AMENDMENT NO. 52 TO FACILITY OPERATING LICENSE NO. DPR-24

AMENDMENT NO. 58 TO FACILITY OPERATING LICENSE NO. DPR-27

SAFETY EVALUATION BY THE OFFICE OF NUCLEAR REACTOR REGULATION
SUPPORTING AMENDMENT NO. 52 TO FACILITY OPERATING LICENSE NO. DPR-24
AND AMENDMENT NO. 58 TO FACILITY OPERATING LICENSE NO. DPR-27

POINT BEACH NUCLEAR PLANT, UNIT NOS. 1 AND 2

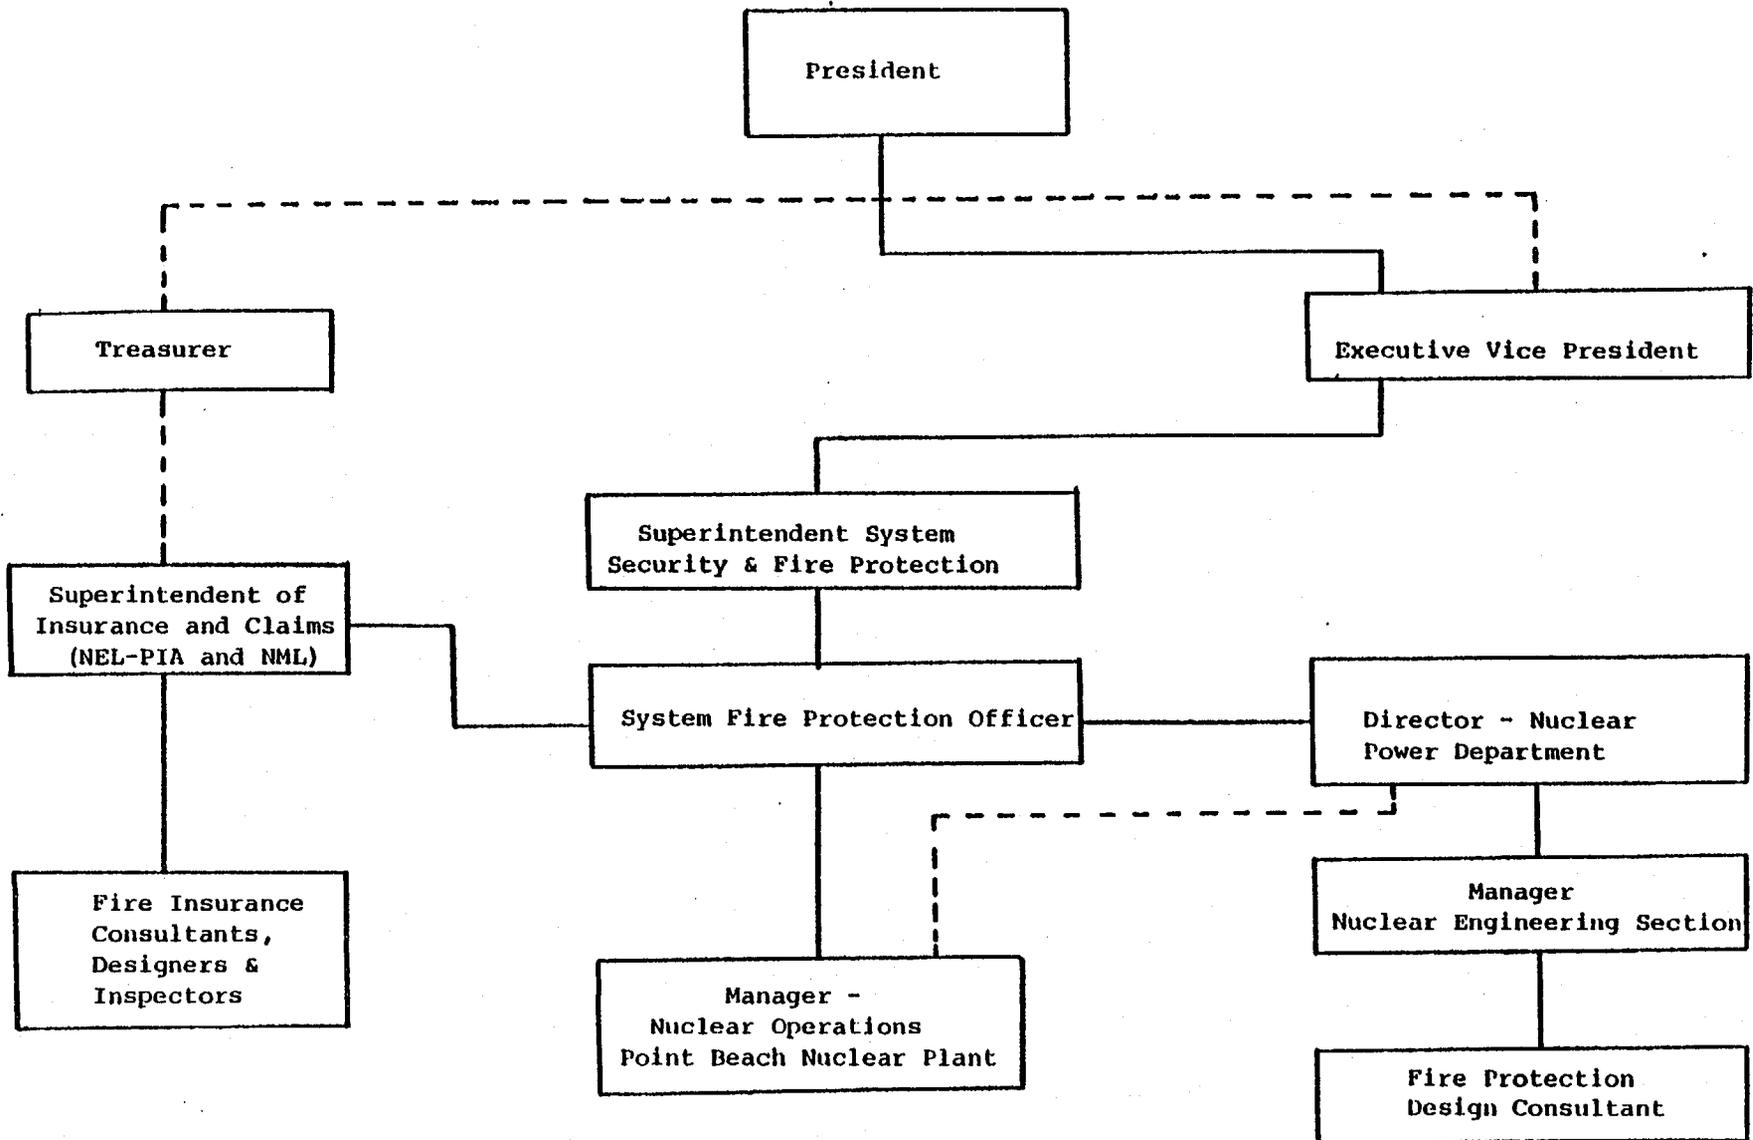
After reviewing the proposed changes, we conclude that Figure 15.6.2-2 does not indicate that the following plant positions are critical:

2. Section 15.6.9.2.A required no change from that previously approved.
3. Figure 15.6.2-2 has been modified to show a solid line in the reporting relationship between the Health Physicist and the Manager-Nuclear Operations in order to conform to previously approved technical specifications. Also the dotted line reporting relationship between the Duty Technical Advisors and the Superintendent-Training has been deleted. The licensee's staff has stated that these were in error of their intent.

4. Figure 15.6.2.2 has been modified to add the words "one per shift" under the position of Duty Technical Advisor in order to conform with the licensee's original February 4, 1981 submittal.

Figure 15.6.2-4

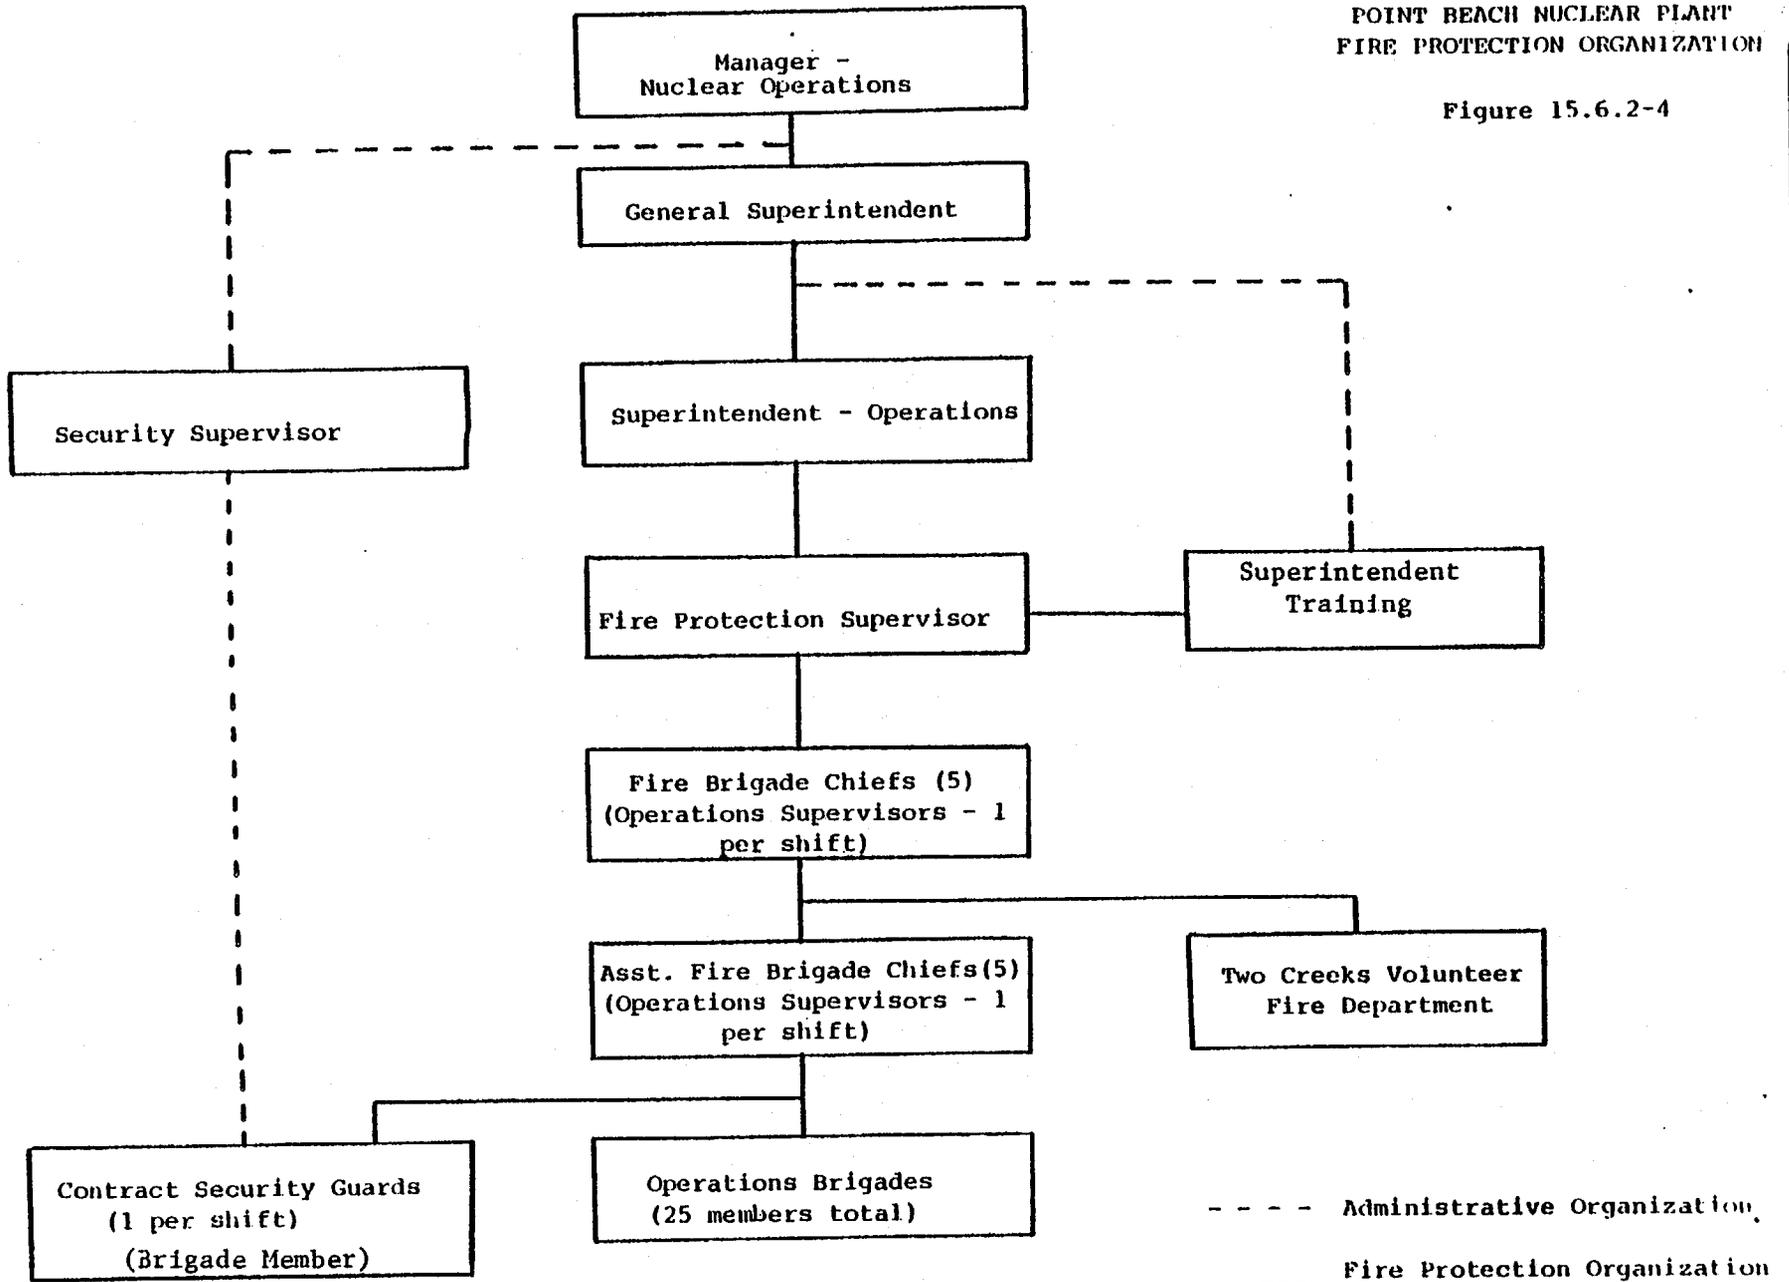
5. Figure 15.6.2-4 and section 15.6.5.2.2 were modified substituting "Superintendent - Training" for "Training Engineer" and "Superintendent-Instrumentation and Control" for "Instrumentation and Control Engineer" to conform with the licensee's June 22, 1981 submittal.
6. Figure 15.6.2-4 was also modified to include the designation of "brigade member" under the position of Contract Security Guards to conform with that previously approved by the NRC.
7. A typing error was corrected on page 15.4.9-1.
